The New Piper Aircraft, Inc.
 2926 Piper Drive
 Vero Beach, Florida, U.S.A. 32960

SERVICE *No. 401A* BULLETIN

Date: May 16, 2000 (M)

INSPECTION OF HEATER FUEL VALVE

Figure 1

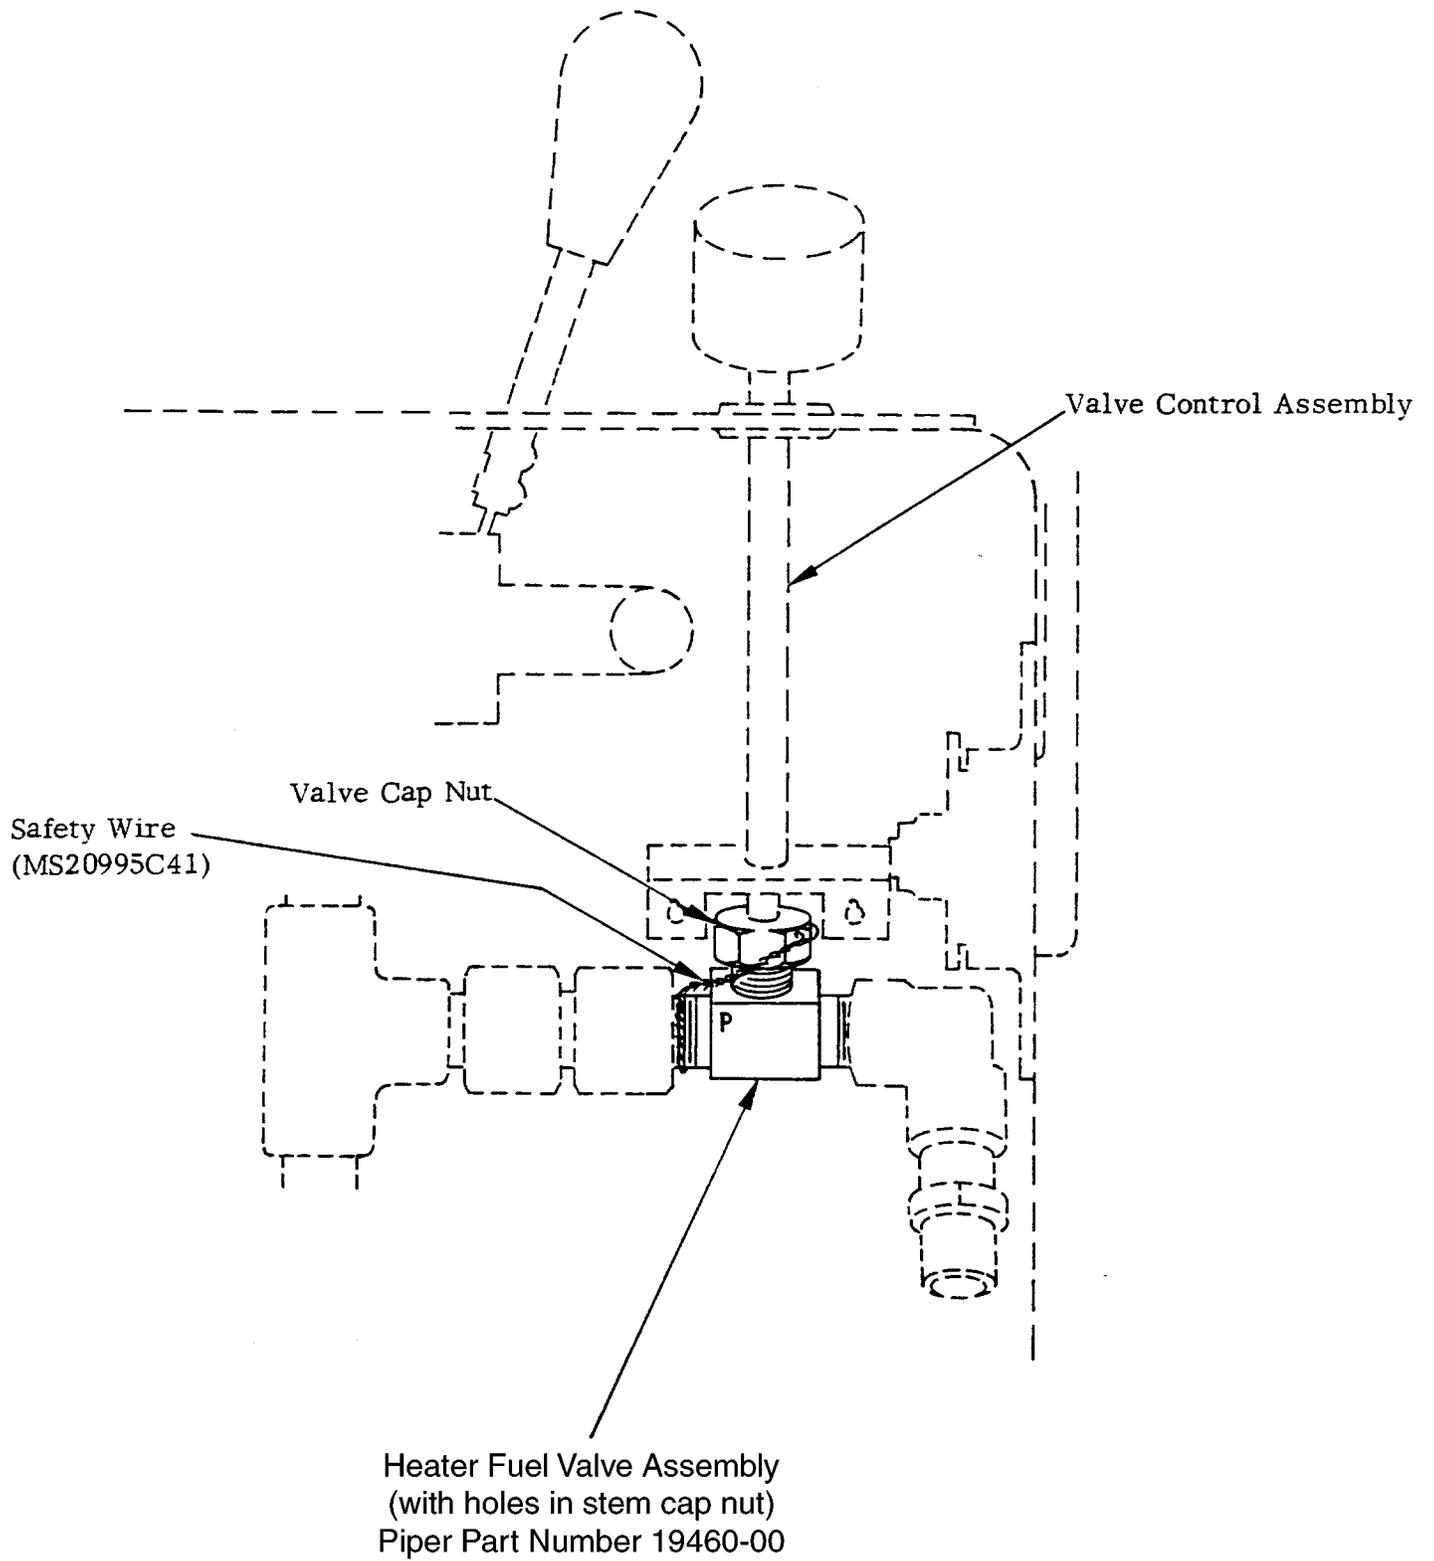
A situation has occurred where the heater fuel valve core “backed out” of the fuel valve, allowing leakage of fuel into the belly of the aircraft adjacent to the fuel system control box assembly. Adequate safetying of the fuel valve cap nut normally prevents the valve core from “backing out”; the current Apache and Aztec Service Manuals, Section XIII, Inspection and Repair of Heater Fuel Valves, illustrate and describe proper safetying of the fuel valve stem cap nut and also states that “if any part of the stem assembly is not drilled for safetying purposes, replace the assembly.” Refer to Figure 1 of this Service Bulletin for an illustration of proper safety wire installation on heater fuel valves with holes in the stem cap nut.

Since there were several previous methods of safetying the fuel valve stem cap nut (not safety wire), and since it is apparent that not all affected aircraft have checked and replaced stem assemblies in accordance with the instructions in the service manual, Part I of this Service Bulletin requests that the heater fuel valve stem assembly cap nut be inspected to insure that it is safetyed properly, and to replace the stem assembly if the proper method of safetying was not employed. Refer to Apache and Aztec Service Manuals, Section XIII, Inspection and Repair of Heater Fuel Valves.

1. Gain access to the heater fuel valve in accordance with the Apache and Aztec Service Manuals, Section XIII, Removal of Heater Fuel Valve.
2. Inspect the stem and cap nut for proper safetying in accordance with Figures 1 or 2 (whichever applies) of this Service Bulletin.
3. If any part of the stem assembly is damaged or is not able to be safety wired properly, or if leakage is evident, replace the assembly.
4. Install the heater fuel valve in accordance with the Apache and Aztec Service Manuals, Section XIII, Installation of Heater Fuel Valve.
5. If proper safetying is evident in accordance with Figures 1 or 2 (whichever applies) of this Service Bulletin, and no leakage is evident, the aircraft may be returned to service.
6. Make appropriate log book entry.

Figure 2

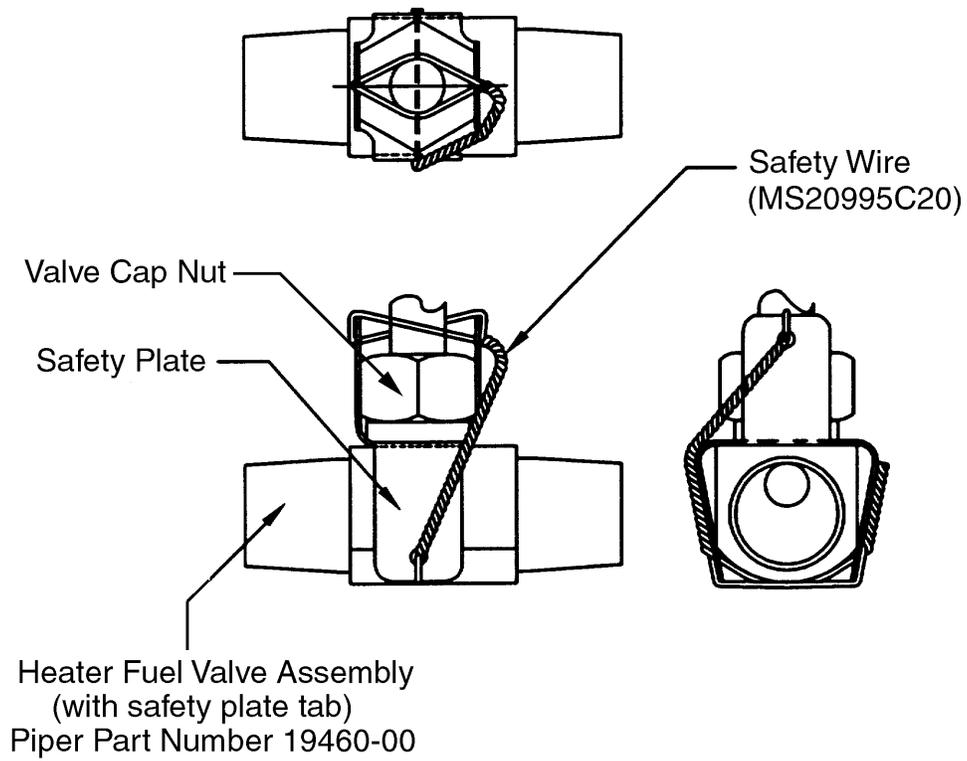
Since heater fuel valves with safety wire holes in the stem cap nut are no longer available, Piper has designed a new heater fuel valve assembly which incorporates a different safety wire installation. The new heater fuel valve is a complete assembly that incorporates a safety plate tab and safety wire, which has been pressure tested to 40 psi. (The Piper Part Number, 19460-00, remains the same.) Refer to Figure 2 of this Service Bulletin for an illustration of proper safety wire installation on heater fuel valves with the safety plate tab.

Part II of this Service Bulletin requests that the heater fuel valve stem assembly cap nut be inspected to insure that it is safetied properly, and to replace the valve assembly if the proper method of safetying was not employed.
